Access Compliance Report

Public Rights-of-Way

(Curb Ramps)

Intersection ID: 7779	Main Street: FRIENDLY_PL	Cross Street: MARCUS_CT	Location: S
ADA ID: 42A5333E3F7F	Ramp Type: BlendTrans1	Initial Pass/Fail: Fail	Overall Compliance: No
		Severity Score: 8.75

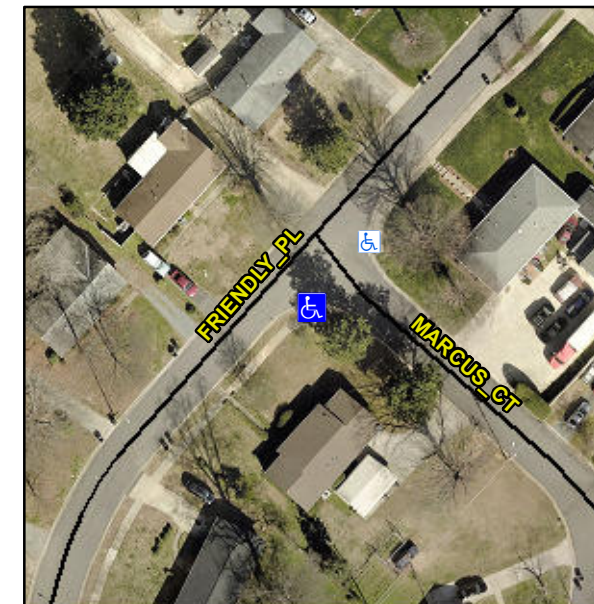
Not Found, R304.5.1

Compliance	Description	Data	Compliance	Description	Data
N/A	Ramp Length (in)	46.5	Yes	BlendTrans Slope (%)	4.8
No	Ramp Width (in)	38.5	Yes	BlendTrans XSlope (%)	1.7
N/A	Flare Type LT	N/A	N/A	Flare Type RT	N/A
N/A	Flare Slope LT (%)	N/A	N/A	Flare Slope RT (%)	N/A
N/A	Flare Traversable LT?	N/A	N/A	Flare Traversable RT?	N/A
N/A	Landing Length (in)	N/A	N/A	DWS Provided?	N/A
N/A	Landing Width (in)	N/A	N/A	DWS Contrast?	N/A
N/A	Landing Slope (%)	N/A	N/A	DWS Length (in)	N/A
N/A	Landing X Slope (%)	N/A	N/A	DWS Full Width?	N/A
N/A	Landing Curb? (Y/N)	N/A	N/A	DWS Offset (in)	N/A
N/A	Shared Landing?	N/A			
N/A	Gutter Ponding?	N/A	N/A	Gutter Slope (%)	N/A
N/A	Gutter Lip Ht (in)	N/A	N/A	Gutter X Slope (%)	N/A
N/A	Painted X Walk1?	No	N/A	Painted X Walk2?	N/A
	X Walk 1 Direction	To NE		X Walk 2 Direction	N/A
	X Walk 1 Width (in)	N/A		X Walk 2 Width (in)	N/A
	X Walk 1 Slope (%)	2.9		X Walk 2 Slope (%)	N/A
	X Walk 1 X Slope (%)	2.6		X Walk 2 X Slope (%)	N/A

N/A	Ramp inside XWalk1?	N/A	N/A	Ramp inside XWalk2?	N/A
	Road Slope (%)	2.6		Clear Space?	N/A
	Road X Slope (%)	2.9	N/A	Clear Space to XWalk (in)	N/A
N/A	Any Obstructions?	N/A	N/A	Storm Grate/Utility Hazard?	N/A
	Obstruction Type			Storm Grate/Utility Type	
		N/A			N/A
			Yes	Surface Condition? (G/P)	Good
			No	Curb Slope (%)	19.0

Remove & Replace Curb Ramp With Two New Directional Ramps or Equivalent.
